**Development Review Board
Panel A Meeting
February 14, 2022
6:30 pm**

- V. Consent Agenda:
 - A. Approval of minutes of the January 10, 2022 DRB Panel A meeting
- VI. Public Hearings:
 - A. **Resolution No. 399. Frog Pond Crossing Subdivision:** AKS Engineering & Forestry, LLC – Representative for Venture Properties, LLC – Applicant and Chaney Paul C Co-Trustee – Owner. The applicant is requesting approval of an Annexation and Zone Map Amendment from Rural Residential Farm Forest 5-Acre (RRFF-5) to Residential Neighborhood (RN) for Approximately for approximately 8.46 acres of property located on the west side of Stafford Road north of SW Frog Pond Lane, and adopting findings and conditions approving a Stage I Preliminary Plan, Stage II Final Plan, Site Design Review of Parks and Open Space, Tentative Subdivision Plat, Type C Tree Plan, Waiver to Open Space location and Waiver to minimum street frontage for a 29-lot residential subdivision. The subject site is located at 27227 SW Stafford Road on Tax Lots 100, 300, and 302, Section 12D, Township 3 South, Range 1 West, Willamette Meridian, Clackamas County, Oregon. Staff: Philip Bradford

A. Resolution No. 399. Frog Pond Crossing

Figure 1. Alternative Street Layout from Preapplication Meeting

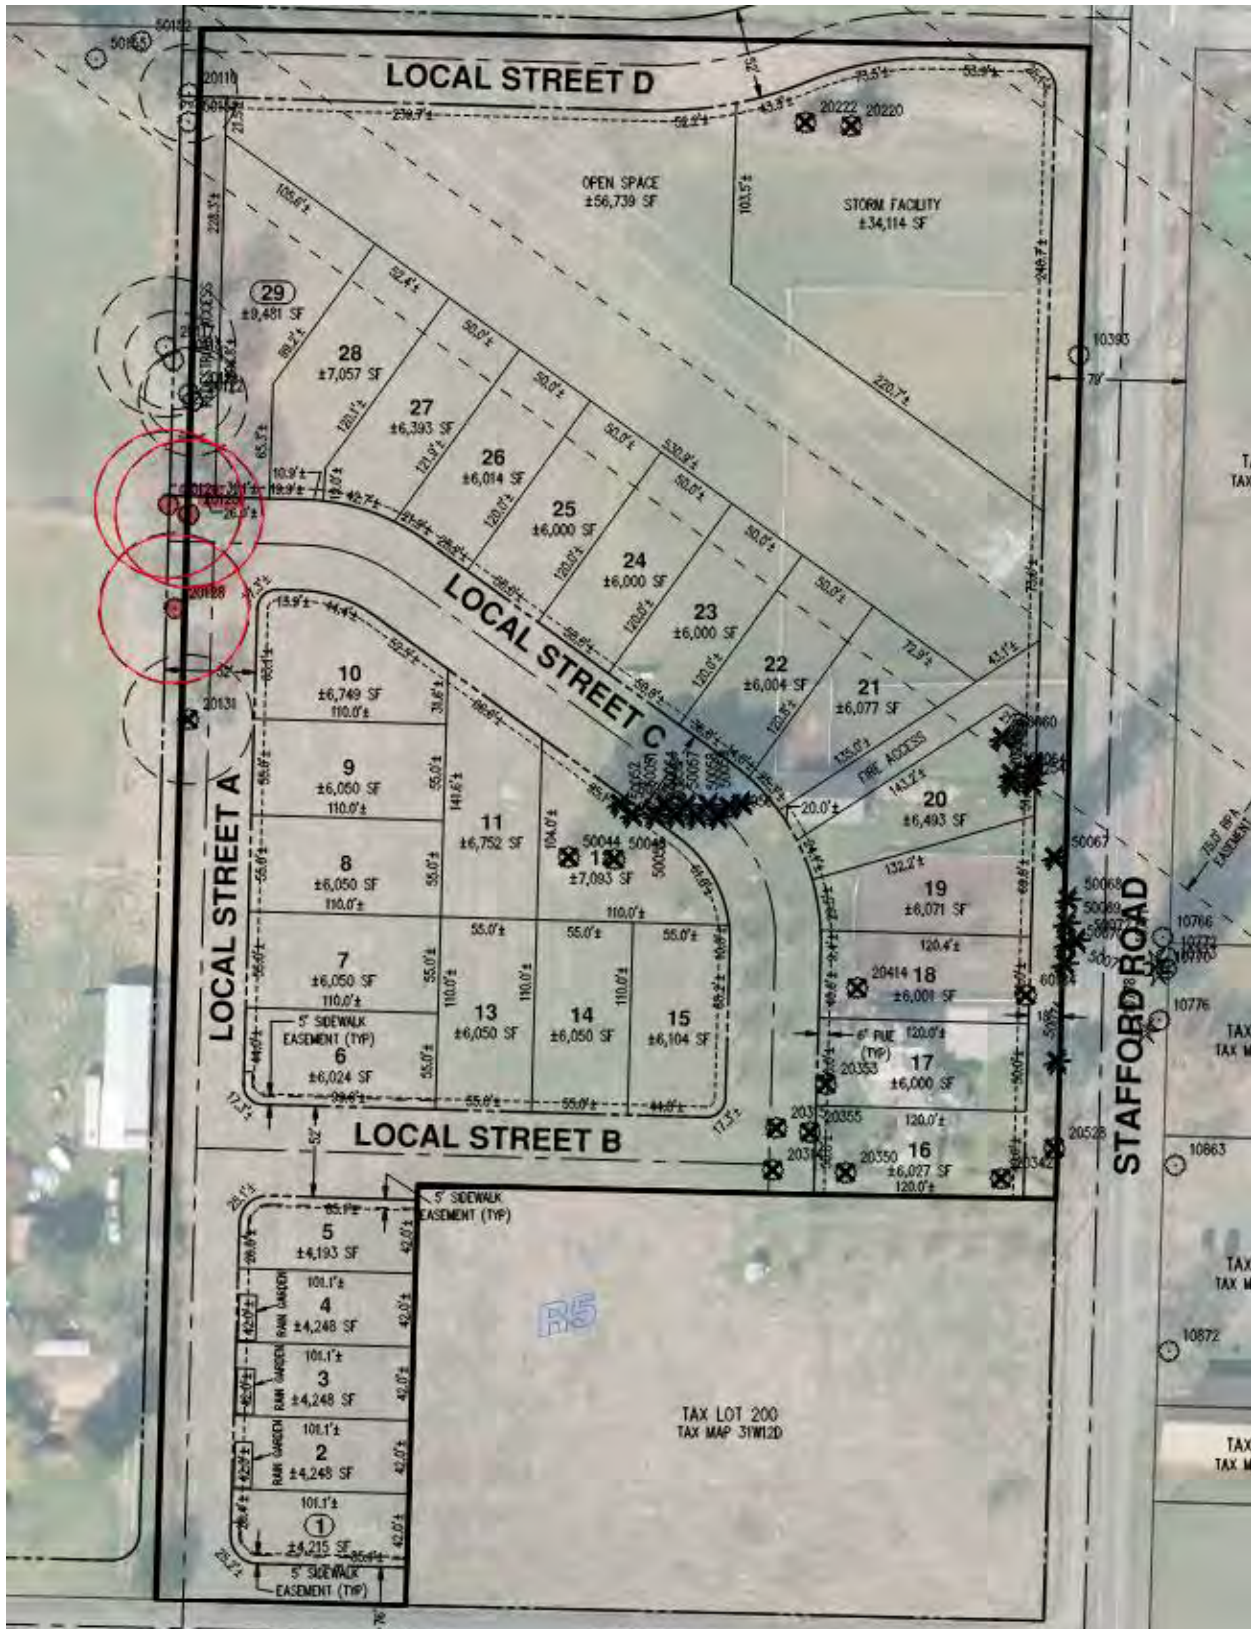
4. *Insufficient findings to explain deviations from the Street Demonstration Plan, particularly relating to the following (see Figure 18 of the Frog Pond West Master Plan and Subsection 4.127 (.10) WC.):*
 - *A missing Pedestrian Connection from Local Street A to Stafford Road in the eastern portion of the site.*

- *Substitution of a Pedestrian Connection for a Public Street in Tract C. While it is noted that this provides an equivalent level of pedestrian connectivity, the provided finding incorrectly identifies the location of the oak tree grove relative to this connection and the provided path and tract do not meet the cross section requirements, including minimum path and planter strip width, identified for Pedestrian Connections as illustrated in Figure 25 of the Frog Pond West Master Plan.*

Response: The narrative has been updated to identify the location of the oak tree grove relative to the pedestrian connection. The Applicant initially studied the site layout with a public street connection as envisioned by the Street Demonstrated Plan. That layout was submitted to City staff for review prior to the preapplication conference. As shown on Figure 1 below, the site design with the public street would require removal of three mature oak trees, which the proposed layout manages to preserve (20128 – 55” DBH, 20125 – 34” DBH, and 20124 – 36” DBH). Because Trillium Street is moved further to the south to avoid impacting the oak trees, the middle block area becomes smaller and lots 6, 7, 15 and 16 are affected. Although not directly in the path of the trees that are being preserved, reducing lot sizes in the middle block enables tree preservation immediately to the north.

In order to achieve the target residential density of 29 lots and provide needed housing while avoiding environmental impact to the onsite wetland and preserving the mature oak trees, the 26-foot width of the pedestrian right-of-way is required to be reduced. The proposed pedestrian connections in Frog Pond Crossing provide a minimum eight-foot paved path. The width of pedestrian right-of-way (ROW) in Tract A is ±21 feet. The paved path is aligned along the eastern edge of the ROW to minimize any impact to the oak tree root system. Based on staff comments, pedestrian connection width in Tract C has been increased to ±16.25 feet, which represents two thirds of the typical section. The remaining width can be accommodated in the adjacent Tax Lot 401, as tree preservation achieved through this layout benefits both properties.

Figure 2. Street Demonstration Plan

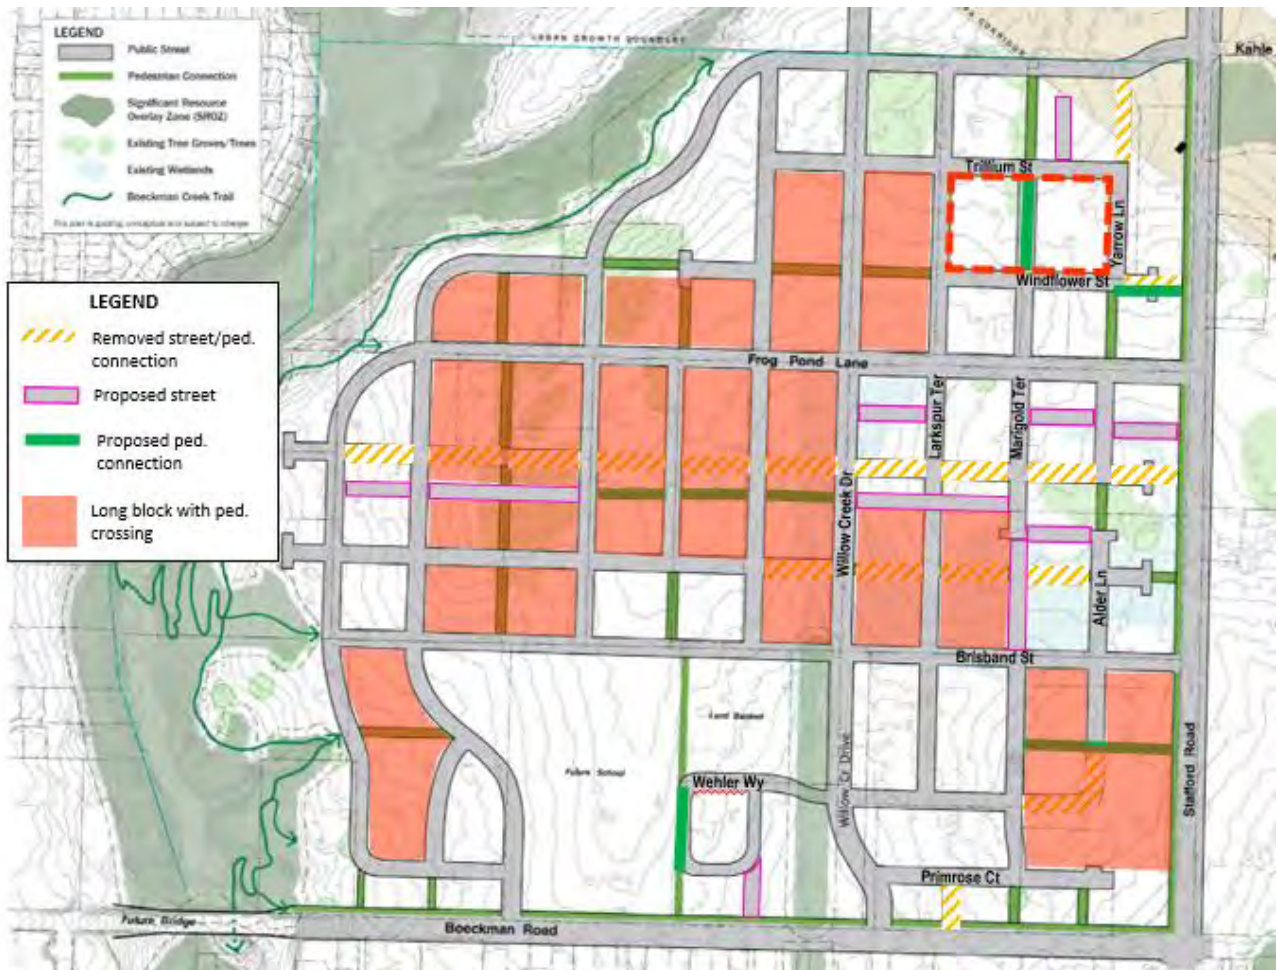
4. Insufficient findings to explain deviations from the Street Demonstration Plan, particularly relating to the following (see Figure 18 of the Frog Pond West Master Plan and Subsection 4.127 (.10) WC.):

- A missing Pedestrian Connection from Local Street A to Stafford Road in the eastern portion of the site.
 - Substitution of a Pedestrian Connection for a Public Street in Tract C. While it is noted that this provides an equivalent level of pedestrian connectivity, the provided finding incorrectly identifies the location of the oak tree grove relative to this connection and the provided path and tract do not meet the cross section requirements, including minimum path and planter strip width, identified for Pedestrian Connections as illustrated in Figure 25 of the Frog Pond West Master Plan.

Response:

The Applicant has been coordinating site planning with the owner of the adjacent property, therefore the proposed deviations from the Street Demonstration Plan in Frog Pond Crossing will not encumber the adjacent property. Furthermore, the proposed pedestrian connection mid-block does not create an unusual condition. As highlighted on Figure 2 below, Frog Pond West street network is not a fully conventional grid pattern. There are at least twelve long blocks with mid-block pedestrian connection that were either originally envisioned on Figure 18 in Frog Pond West Master Plan, or subsequently approved by the City through a modification. In Frog Pond Crossing, the proposed substitution of a street with a pedestrian connection in Tract C is justified by the preservation of three mature Oregon White Oak trees.
